# Access Compliance Report

## Public Rights-of-Way

Intersection ID: 42646	Main Street: E_4TH_ST	Cross Street: S_TORRENCE_ST	Location: SE
ADA ID: 457C1C550BBD	Ramp Type: PerpDiag	Initial Pass/Fail: Fail	Overall Compliance: No
Severity Score: 12.5			
Codes/Mitigation Info/Possible Solution		Field Measurements/Component Compliance

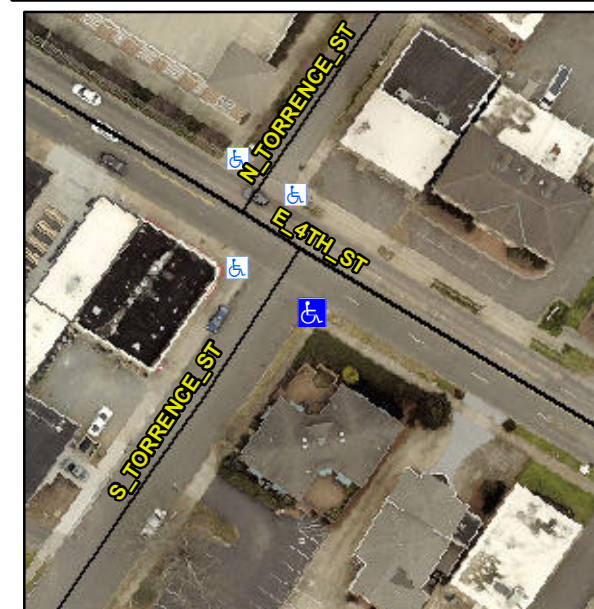
**Not Found, R304.2.2**

Compliance	Description	Data	Compliance	Description	Data
N/A	Ramp Length (in)	69.5	No	Ramp Slope (%)	8.6
Yes	Ramp Width (in)	57.0	Yes	Ramp XSlope (%)	0.0
N/A	Flare Type LT	N/A	N/A	Flare Type RT	N/A
N/A	Flare Slope LT (%)	N/A	N/A	Flare Slope RT (%)	N/A
N/A	Flare Traversable LT?	N/A	N/A	Flare Traversable RT?	N/A
N/A	Landing Length (in)	N/A	N/A	DWS Provided?	N/A
N/A	Landing Width (in)	N/A	N/A	DWS Contrast?	N/A
N/A	Landing Slope (%)	N/A	N/A	DWS Length (in)	N/A
N/A	Landing X Slope (%)	N/A	N/A	DWS Full Width?	N/A
N/A	Landing Curb? (Y/N)	N/A	N/A	DWS Offset (in)	N/A
N/A	Shared Landing?	N/A			
N/A	Gutter Ponding?	N/A	N/A	Gutter Slope (%)	N/A
N/A	Gutter Lip Ht (in)	N/A	N/A	Gutter X Slope (%)	N/A
N/A	Painted X Walk1?	No	N/A	Painted X Walk2?	No
	X Walk 1 Direction	To NE		X Walk 2 Direction	To NW
N/A	X Walk 1 Width (in)	N/A	N/A	X Walk 2 Width (in)	N/A
	X Walk 1 Slope (%)	1.7		X Walk 2 Slope (%)	0.7
	X Walk 1 X Slope (%)	0.2		X Walk 2 X Slope (%)	0.6

**Remove & Replace Curb Ramp With Two New Directional Ramps or Equivalent.**
